# BOND HOUSE

# BOND HOUSE : PROPOSED ALTERATION

# WALL BETWEEN NATHAN HALE SCHOOL/ 88 LAMBERT

## REMOVAL OF SUN ROOM ADDITION

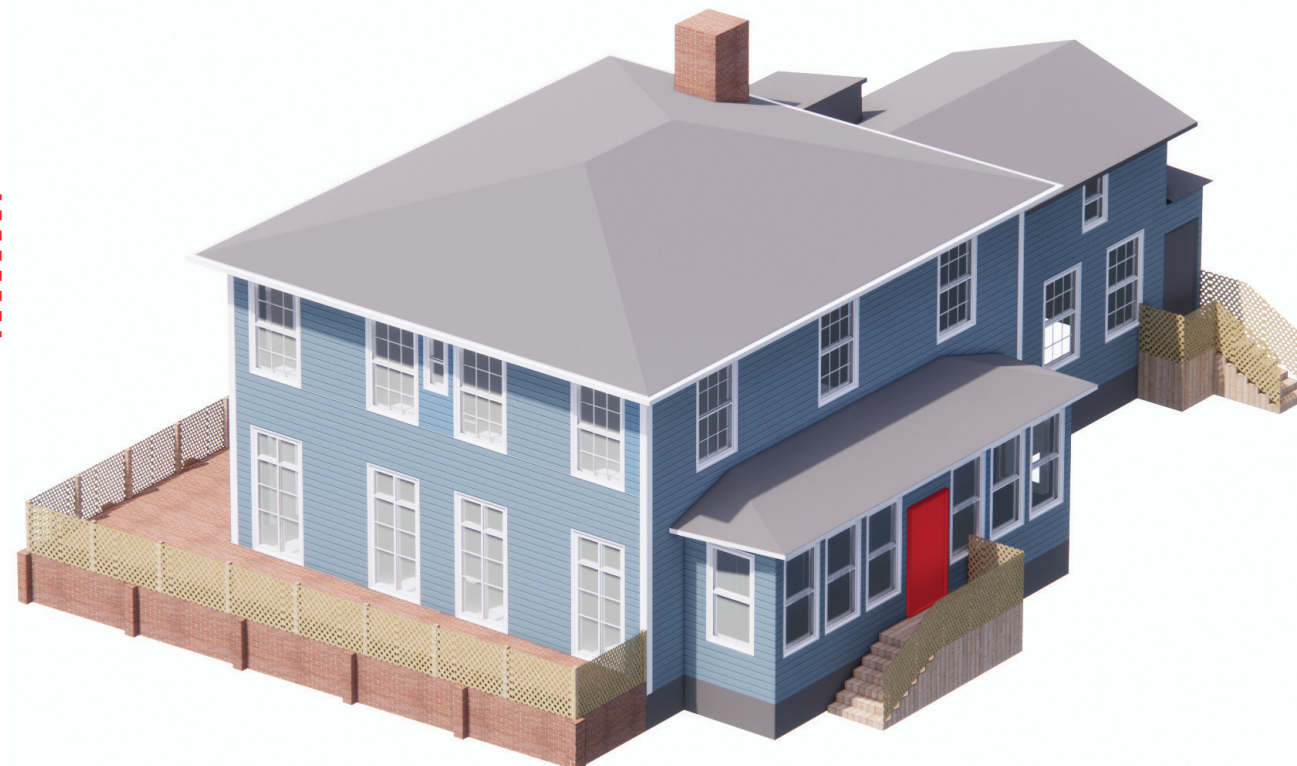
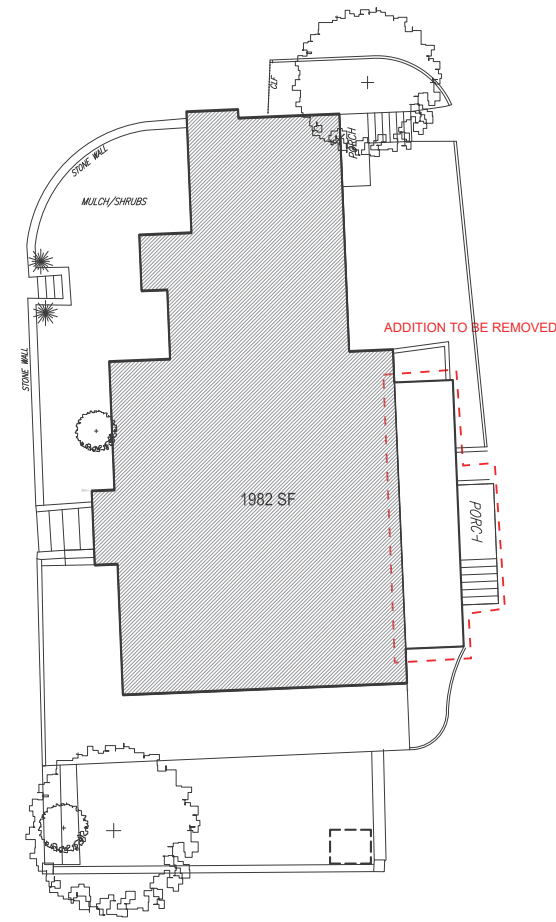
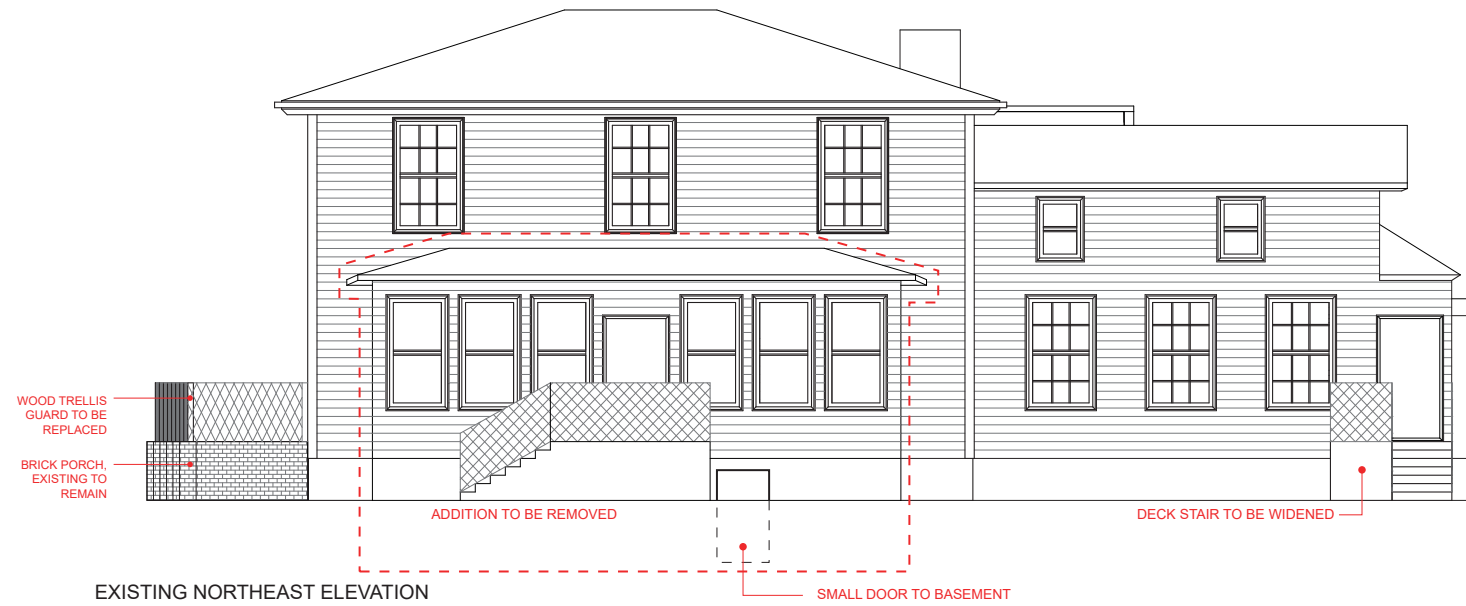
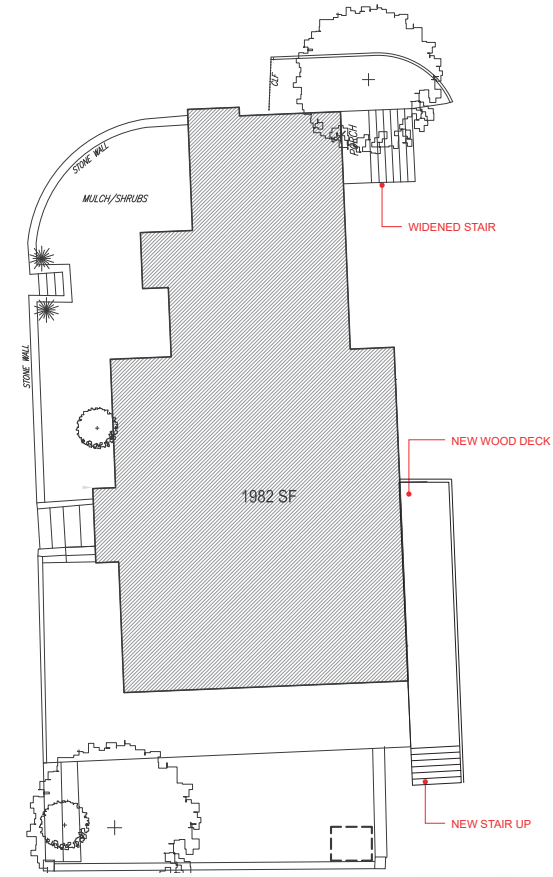
- The Board requested more information on the demolition of the Bond House sun room
- The sun room addition was not found by our team to have any historical significance
- The demolition of the addition will reveal the Richard Bond-designed facade still intact

CURRENT WALL

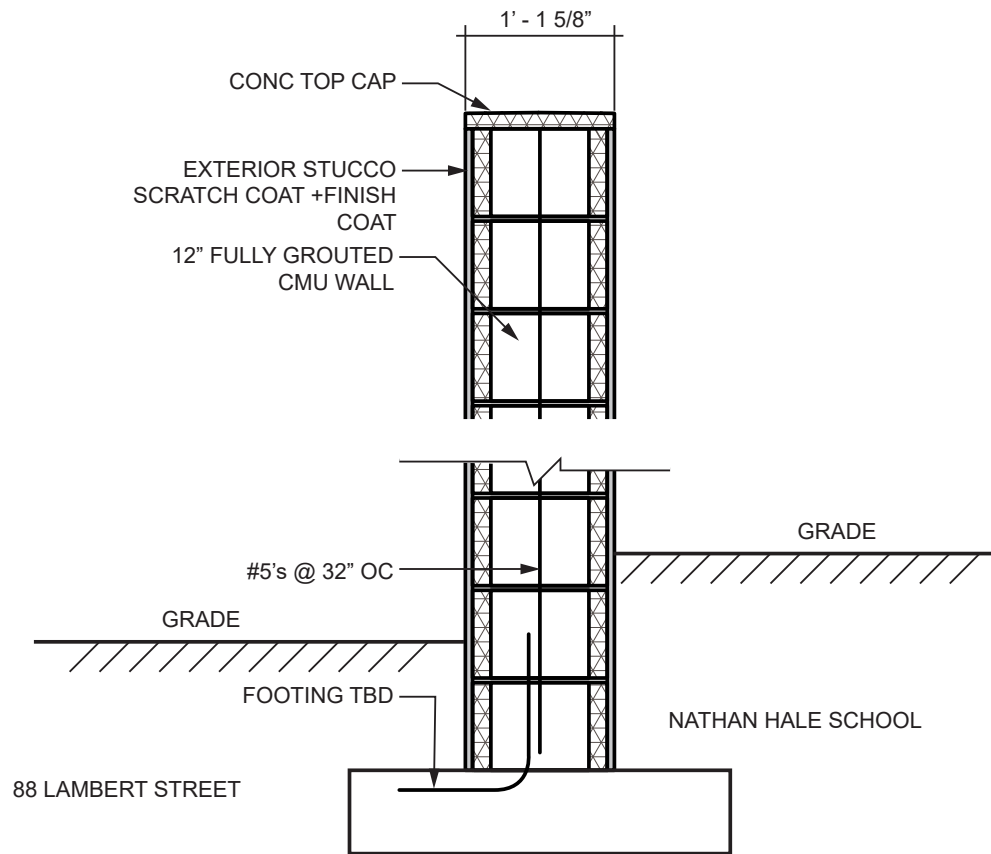
- The Board requested a more thorough proposal for the design of the wall to be demolished between the property at 88 Lambert and the Nathan Hale School
- The Board requested retaining the current height of the wall
- The current wall is in disrepair, and is structurally dependent on the current garages on the 88 Lambert site. Current wall preservation is not viable.
- Murals on the Nathan Hale side are removable, and will be preserved and reattached when the new wall is completed.

CURRENT WALL HEIGHT = 12'

WALL HEIGHT SHOWN AT 2/25 LANDMARKS MEETING = 18'

UPDATED PROPOSAL 04/28/20

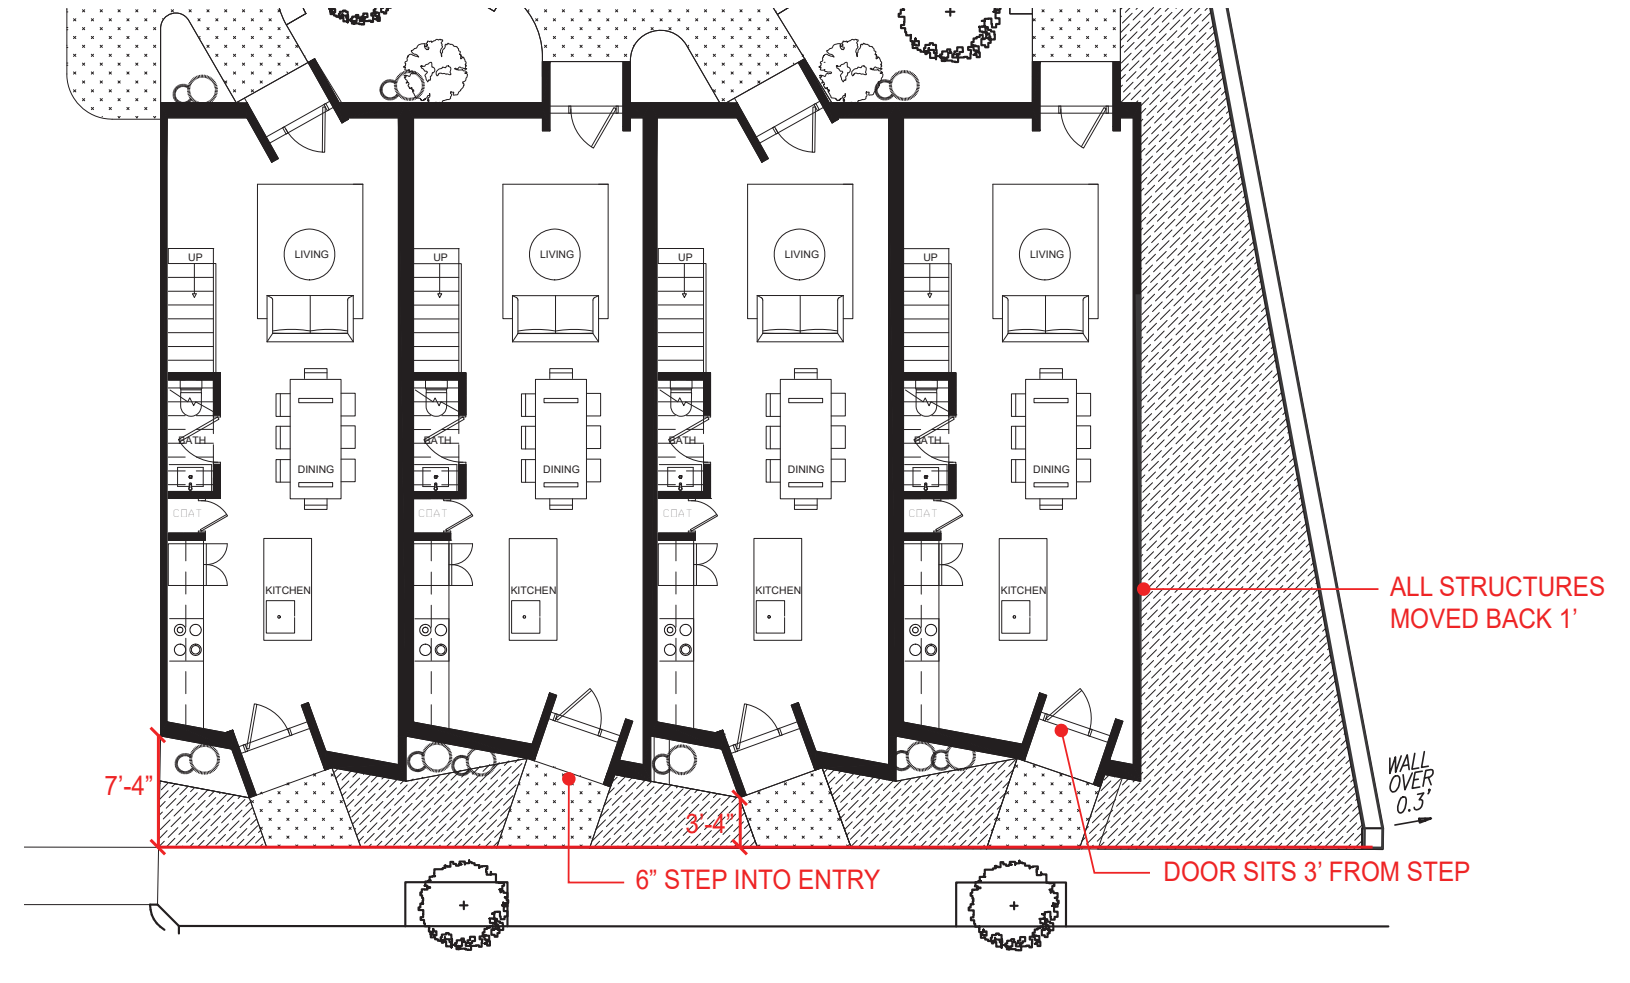
- The Board noted that the current setback and front door arrangement did not feel right on Lambert Street
- The entry (within 2 feet of sidewalk) did not provide an adequate buffer between the public to private spaces.
- The Board asked that we explore altering the setback and entry to better accommodate a porch or stoop transition to the sidewalk & street.

ALL STRUCTURES HAVE BEEN PUSHED BACK BY 1'

FRONT DOORS PUSHED BACK 3'

ADDITION OF A 6" STEP INTO FRONT ENTRY

# LANDSCAPE PLAN

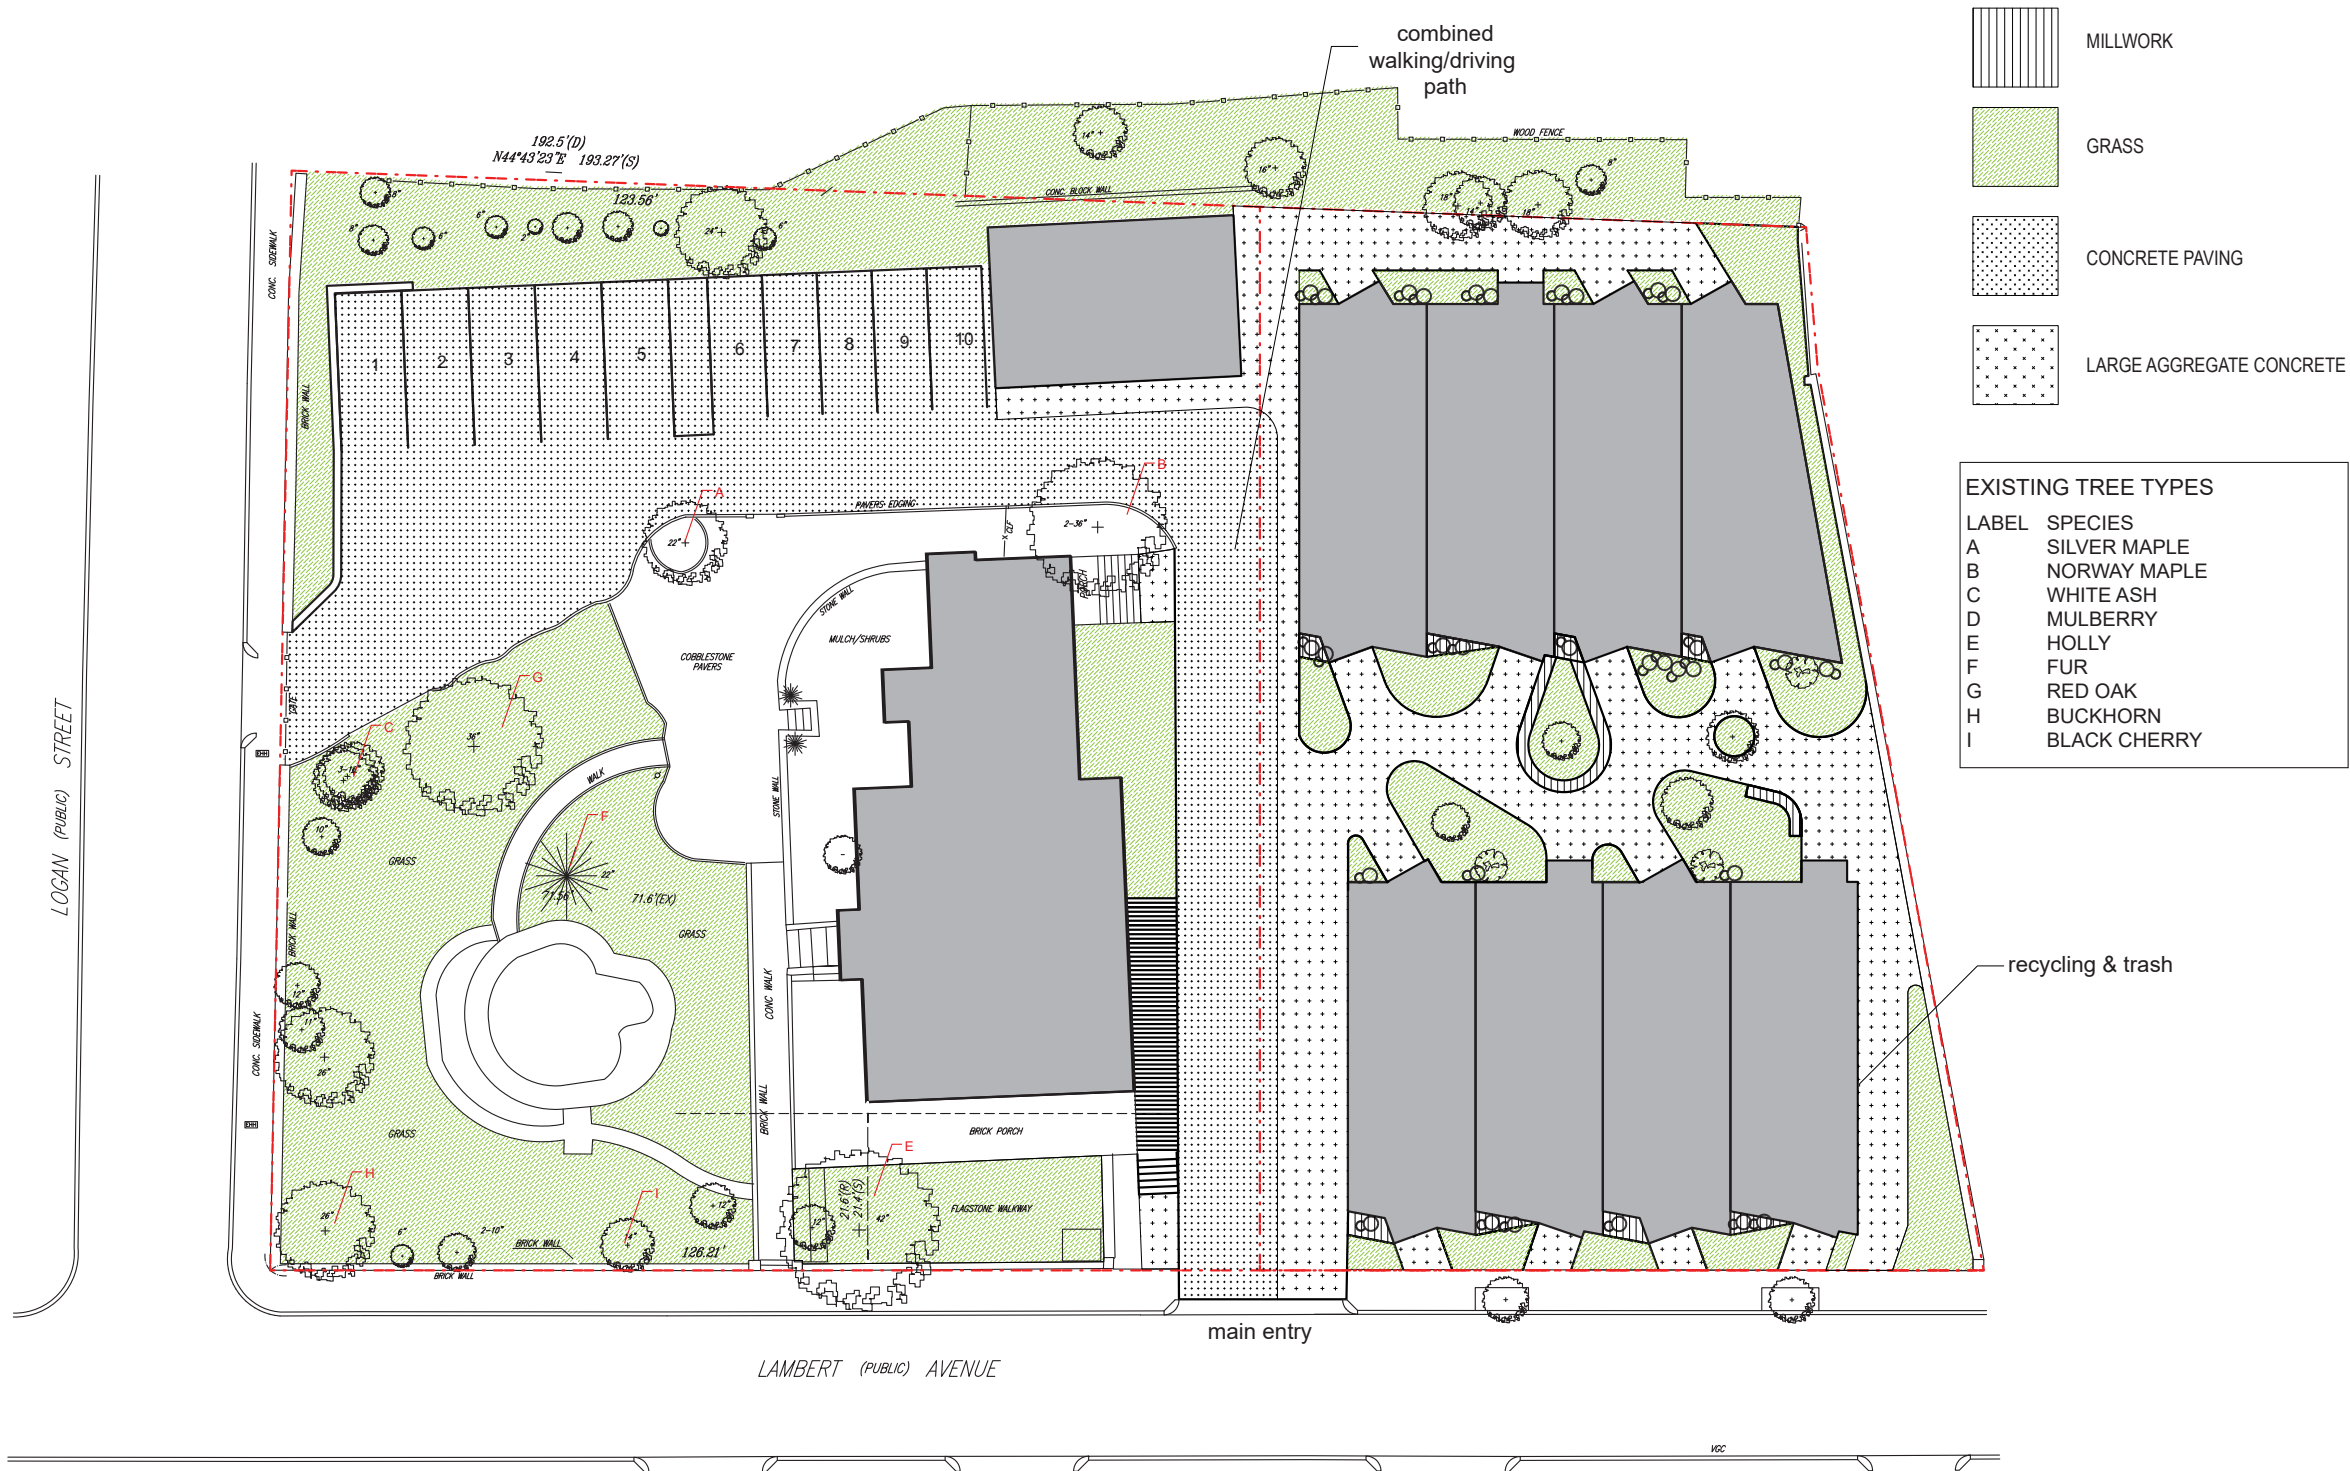
- The Board asked that a landscape design for the interior courtyard be developed and presented.
- The design team has been working on several schematic schemes for the landscape layout, focusing on weaving hard-scape with soft-scapes to incorporate local plant and tree species. The courtyard is meant for recreation and communal gathering, and the design intends to provide a mixture of permeable and impermeable surface materials.
